Addendum 2

March 9, 2022

Addition and Renovation to: Norris Middle School
 5 Norris Square
 Norris, TN 37828

Job Number: 210042.04

ENTRY PARAPET
SCALE: 1 1/2" = 1'-0"

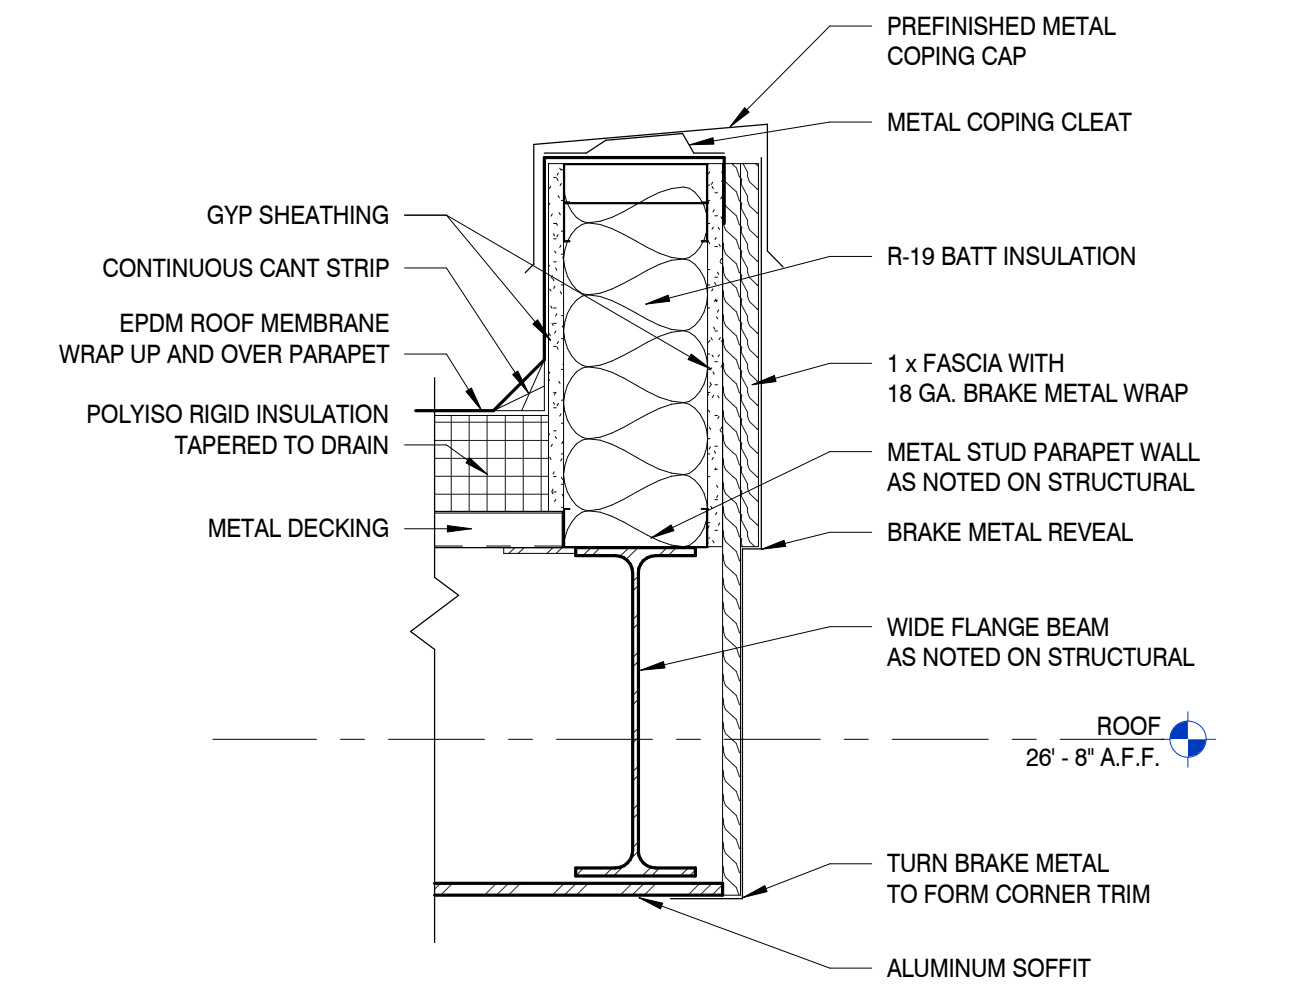
3. **ARCH** - Can we get more detail at the conventional framed main entry canopy cover, specifically the perimeter parapet wall framing. The structural drawings note metal stud parapets (9 & 11 / S502), however I don't see a section on the architectural drawings that notes wall sheathing, cladding, etc.

Answer and drawings/specs included: See Detail 10/A302.

SHEET NO.: **F401**

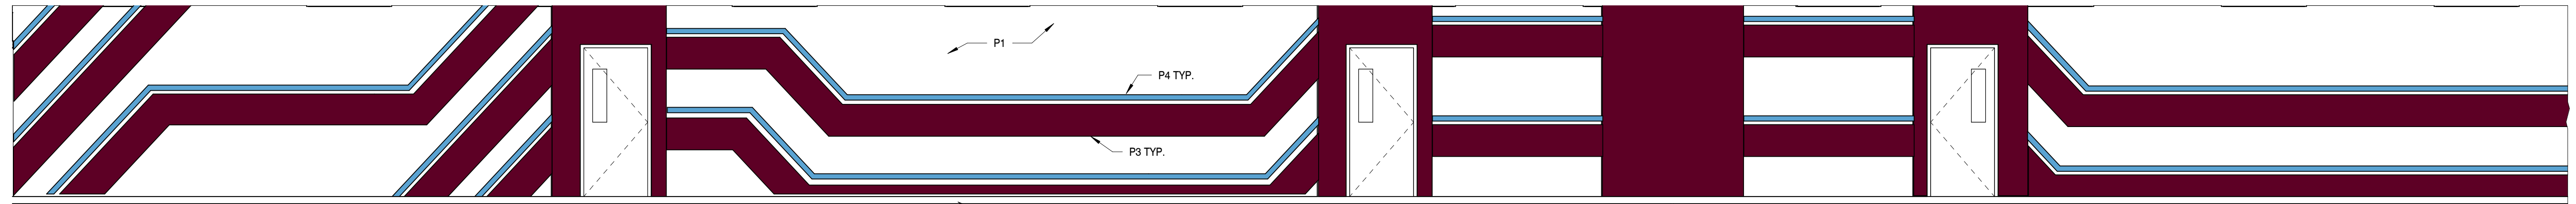
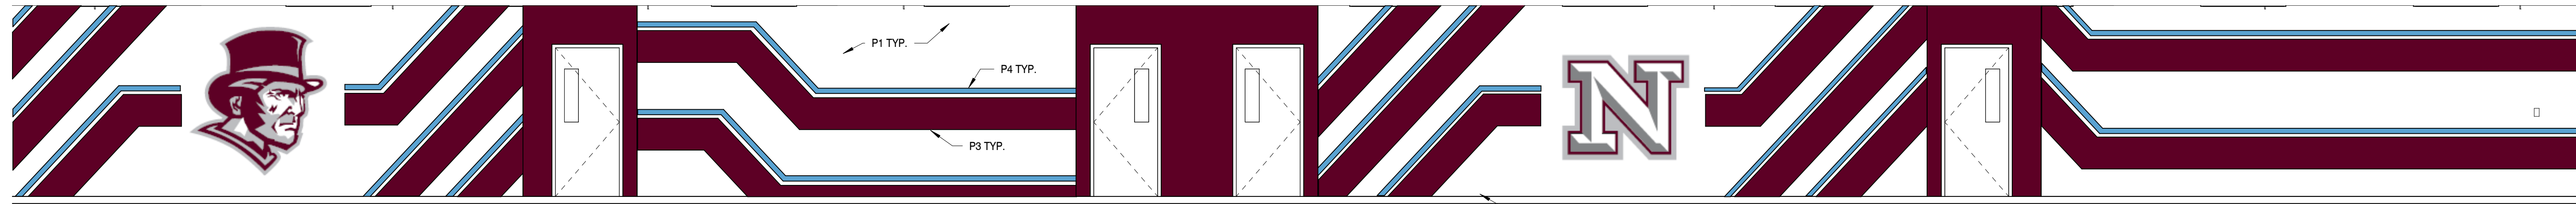
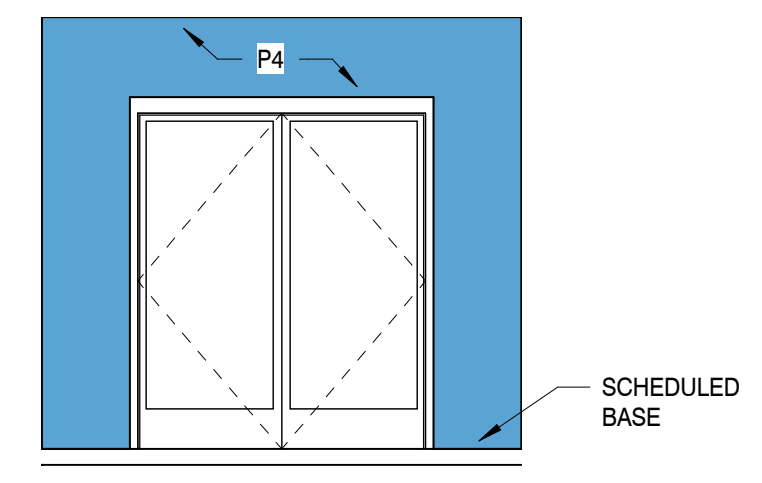
1. Page F401 it states "Painted Wall Graphics" can you provide what these graphics will be ? I can not locate any further information.

Please see attached revised drawing sheet F401 for wall graphics.

FLOOR PLAN - FIRE PROTECTION

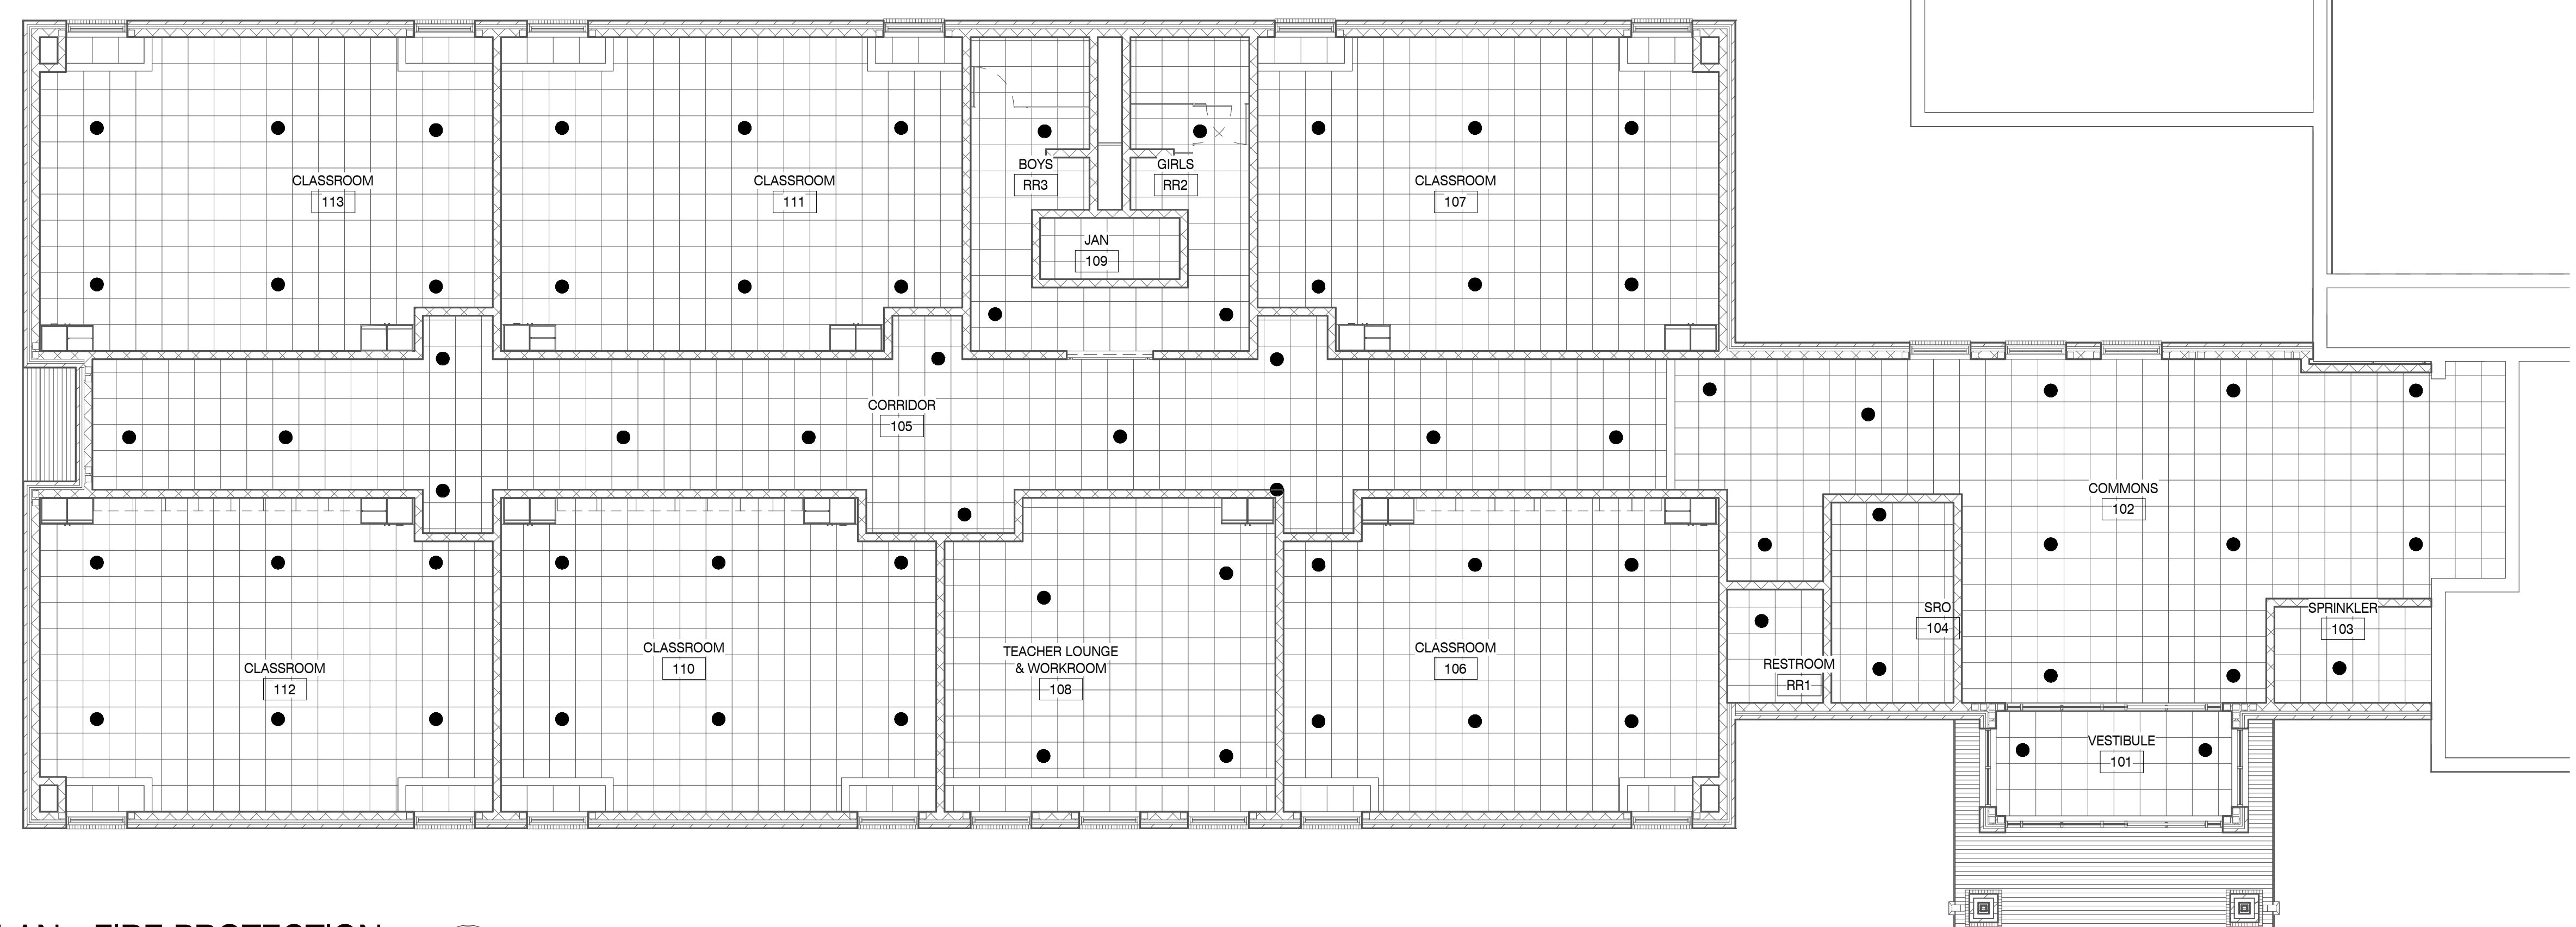
10. **FIRE PROTECTION** - You cannot run a fire line under a building like it's shown on the FP drawings unless you want to Arch the footings, install valves and put this pipe in an open trench with a grate across it.

Answer and drawings/specs included: Fire line will be routed around the building to the sprinkler room. See sheets C500 and FP101.
